UNITED STATES PATENT AND TRADEMARK OFFICE

APPLICATION NO.	FILING DATE	FIRST NAMED INVENTOR	ATTORNEY DOCKET NO.	CONFIRMATION NO.
09/838,348	04/19/2001	Randall W. Ojanen	K-1786	2490

Office Action Summary

DETAILED ACTION

FIG. 5

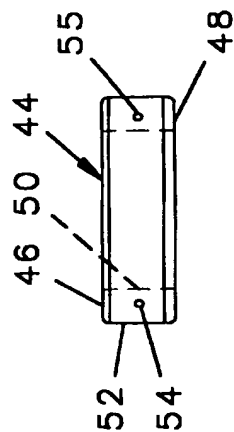
Steinke discloses a retainer sleeve (10) having at least one outwardly protruding surface/dimple (17, see col. 3 line 53), the retainer has a cylindrical circumference and a thickness dimension, it appears that the amount of radial projection of said protruding surface beyond the cylindrical surface of the retainer is about 15-30 percent of the thickness dimension of said retainer (see attached marked up Fig. 5).

FIG. 6

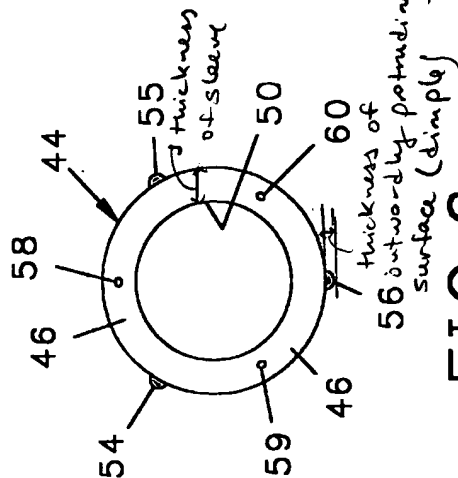
Sollami discloses a cutting tool assembly comprising a retainer sleeve (see Figs. 5,6), the retainer is cylindrical and has a thickness, the retainer sleeve includes at least one radially outward projecting dimple (54,55,56). The projection of the dimple(s) beyond the cylindrical surface of the retainer appears to be about 15-

30 percent of the thickness dimension of the retainer (see attached marked up Fig. 6).
